Figure 11.9 – Indicative ground level lowering, rear courtyard. Cumulus Architects.

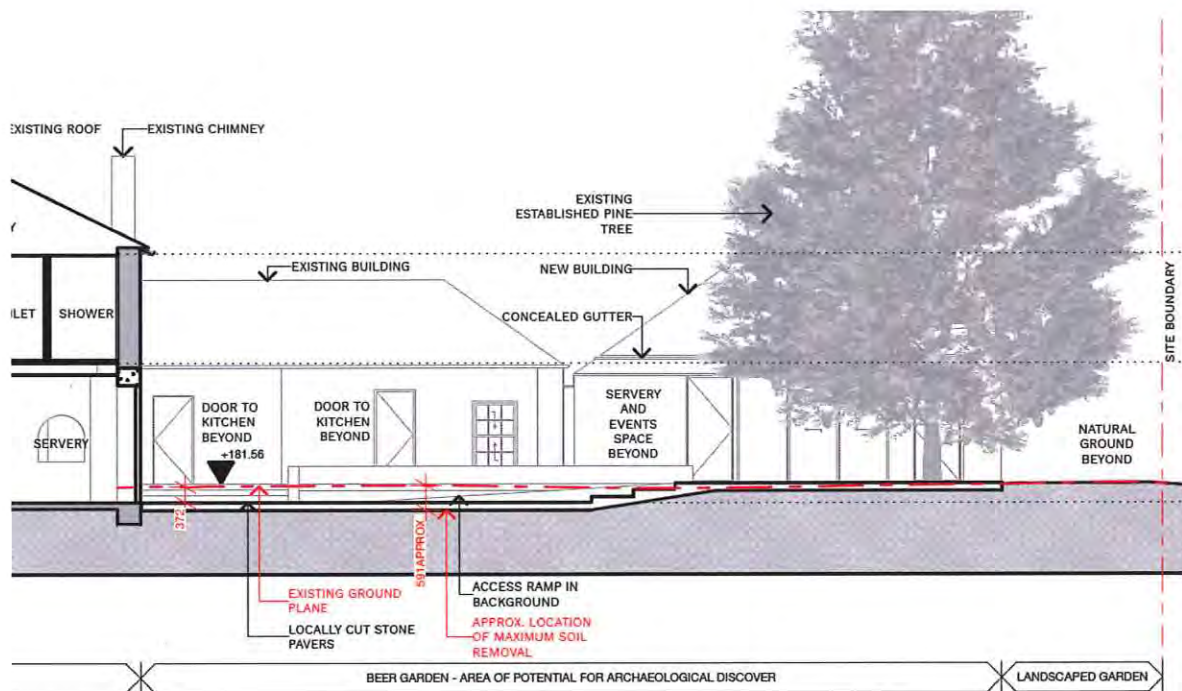
- A general lowering of the ground level behind the rear section of the hotel to address damp and grading issues. This will be approximately 590mm in depth close to the rear of the hotel, (to also allow for new ground surfaces). As per above, it is not known (but possible) whether much of this area is later fill which may be on top of earlier archaeological remains.
- Strip foundations approximately 600mm below the lowered ground level for the foundations associated with the open pavilion and toilets.
- Excavations for services associated with the proposed new buildings.
